Network Working Group
Request for Comments: 1151
Updates: RFC 908

Version 2 of the Reliable Data Protocol (RDP)

This RFC suggests several updates to the specification of the Reliable Data Protocol (RDP) in RFC-908 based on experience with the protocol. This revised version of the protocol is experimental.

RDP Header Format
Figure 1

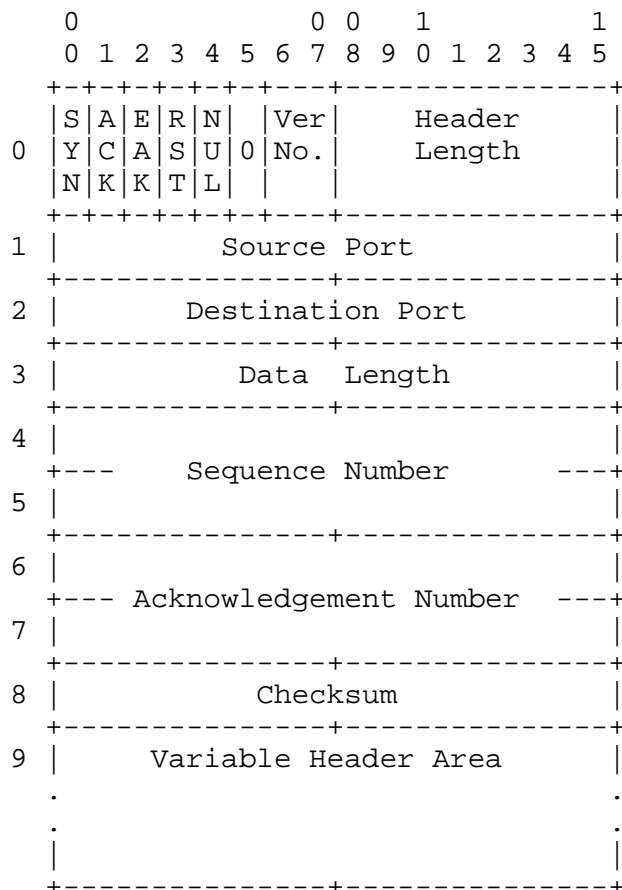
There are three changes to the protocol header: the checksum algorithm has been changed, the port size increased, and the version number incremented. The new header format is shown in Figure 1.

The major discovery during the testing of the protocol is that cost of computing the the RDP checksum proved surprisingly variable; its performance was more heavily affected by the host's data representation than anticipated. Optimized checksum implementations on two comparable hardware bases gave performance that differed by a factor of five. Since the speed of the checksum is a key factor in the performance of the protocol itself, this variation caused a noticeable difference in throughput.

The 8-bit port size is probably too small to support a large range of applications. Accordingly, the port size is now 16-bits. Port numbers less than 1024 are reserved for well-defined applications. Allocable ports begin at port number 1024.

Finally, because the checksum and port size have been changed, the version number has been increased to 2.

The wide variation in performance on comparable machines was felt to be undesirable, so the checksum has been changed. RDP now uses the 16-bit TCP checksum, which is specified on page 16 of RFC-793.
